**CHANGES:**

Job Title 1602 - 182_184 High Holborn		Client Covent Garden Investment S.A.R.L
Drawing Title PROPOSED SECTION 02		Drawing Number & Revision HH-P-26-MF-01-02_P4
Scale (at A0) 1 : 100@A1	Date Amended 29.03.2017	Amended By GK
Checked Checker	Date Created	Drawn By Author

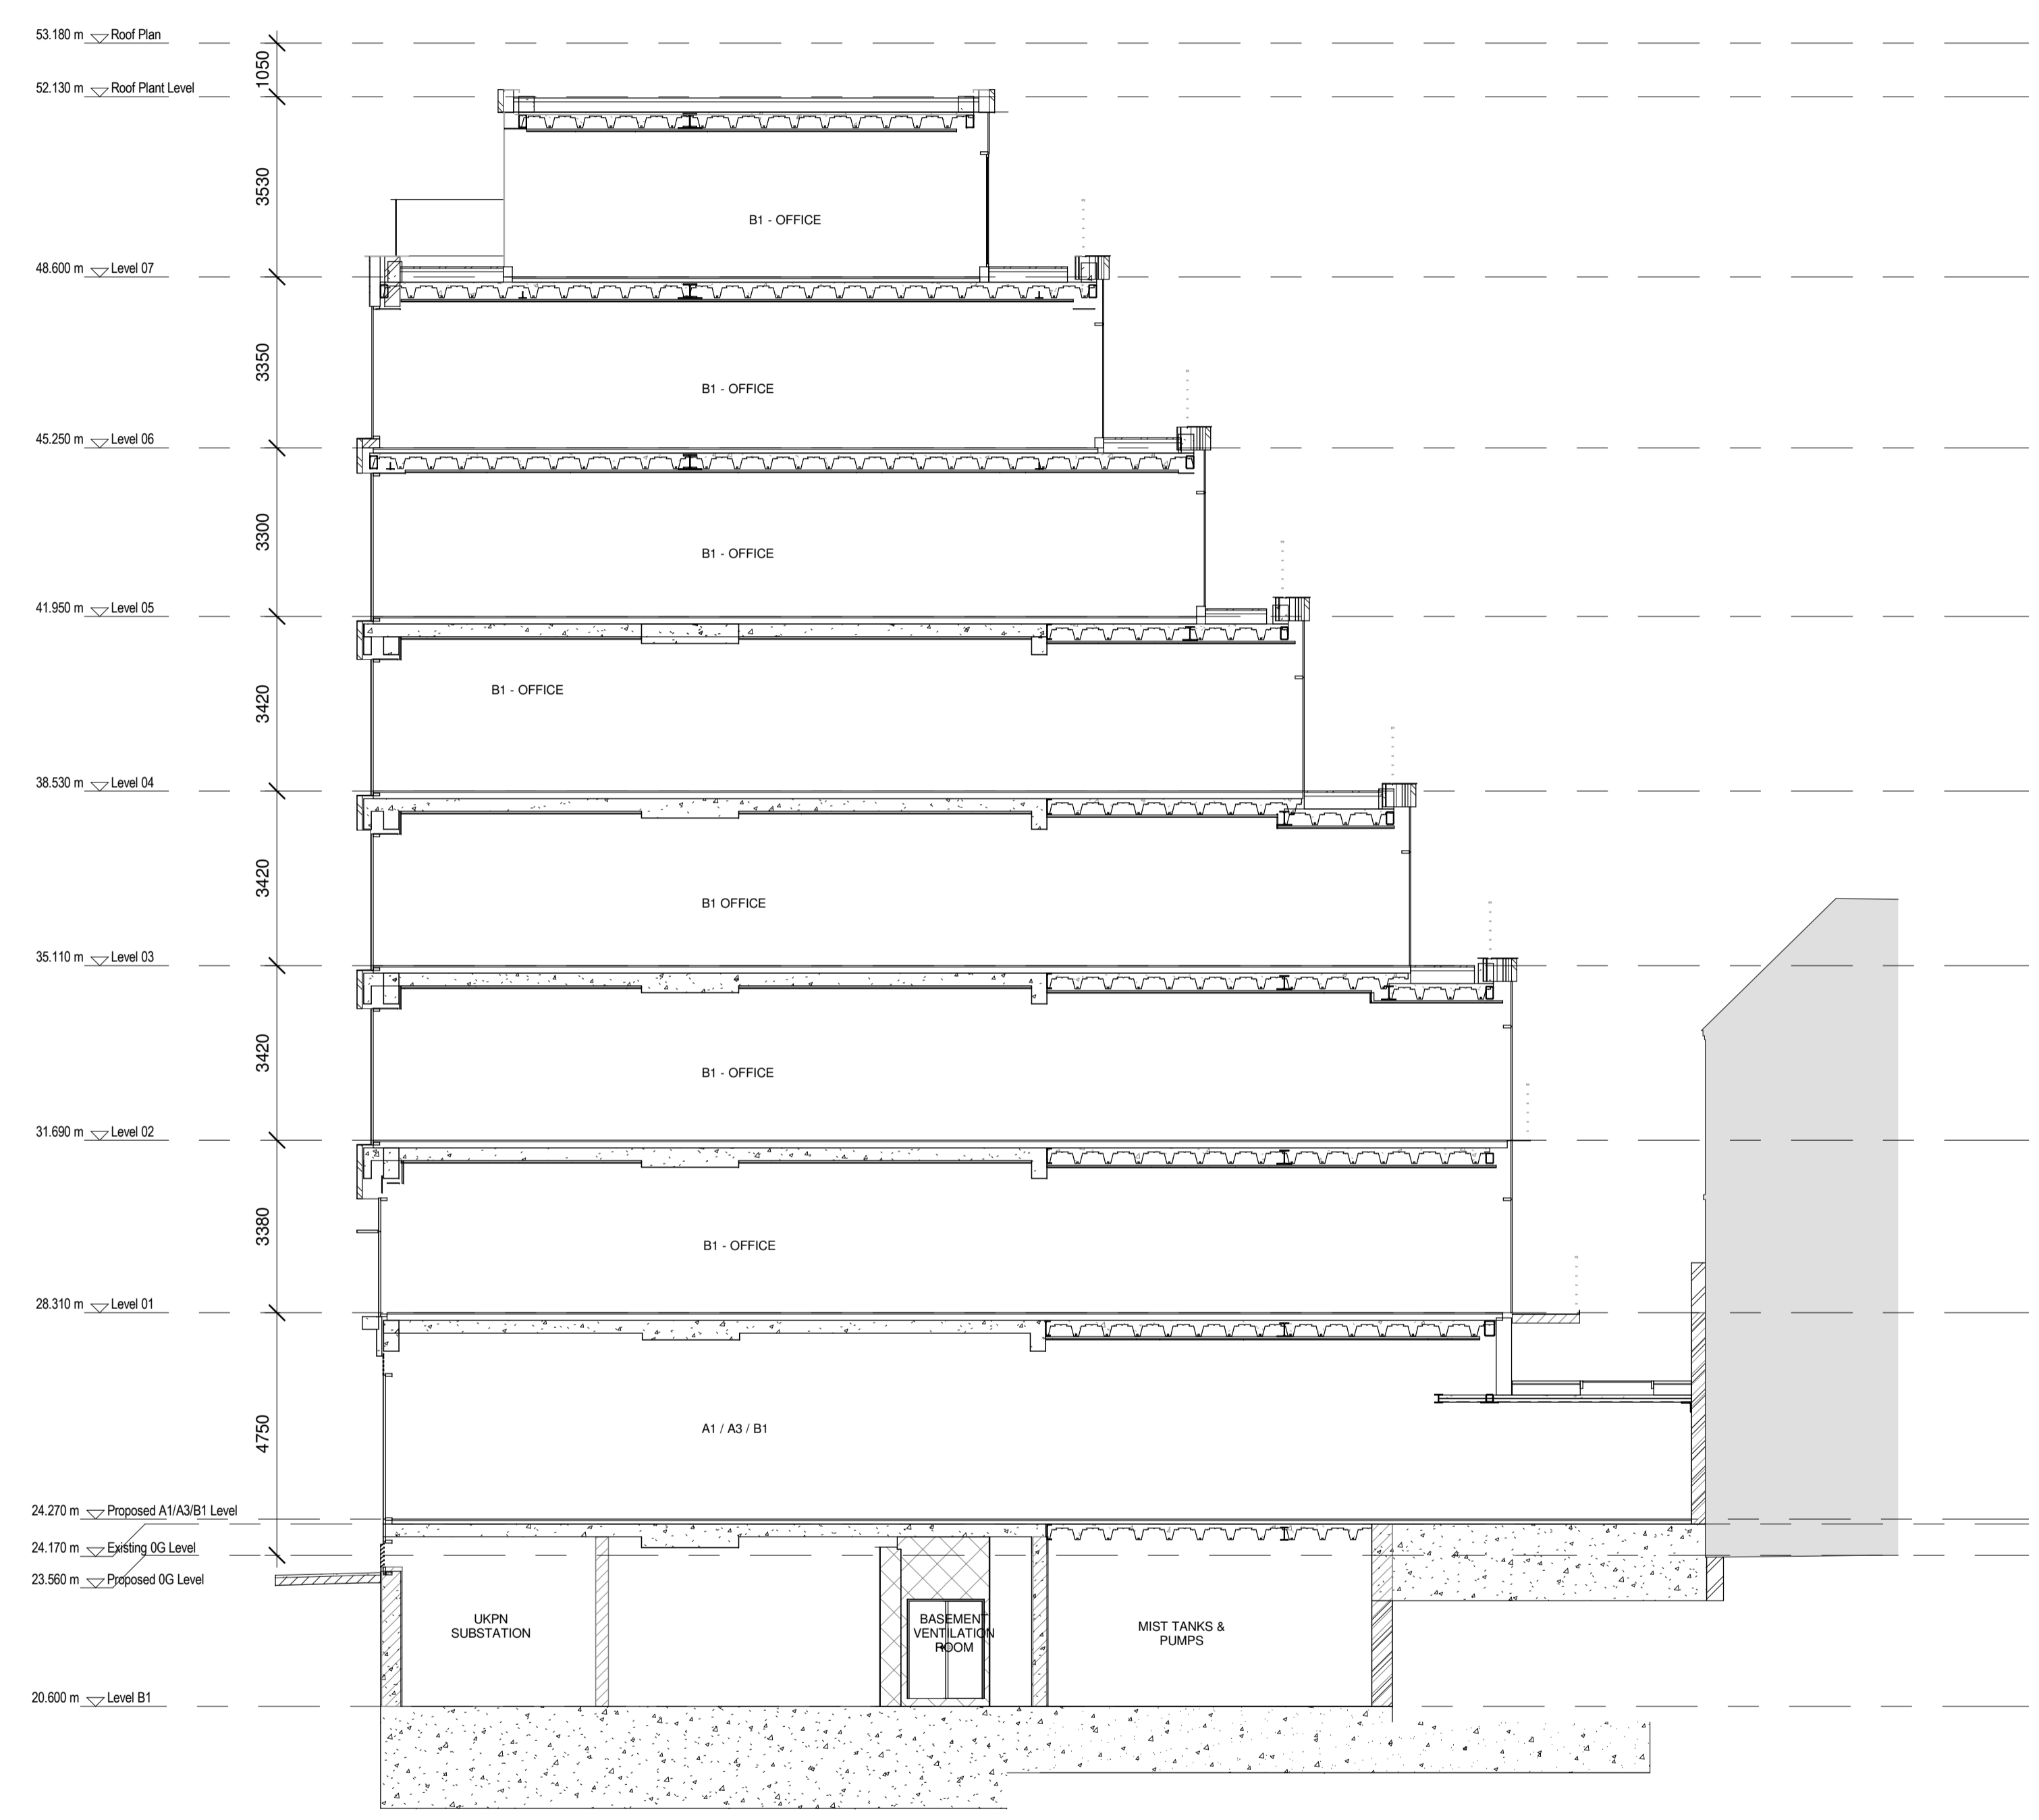
- There is an increased height on levels 6, 7 and Roof Plant in order to accommodate higher clear ceiling heights. Level 6 (FFL) has been increased by 150mm, level 7 (FFL) by 300mm and the roof plant level by 450mm-which is the total increase of the mass in terms of height. The top roof level has remained intact.
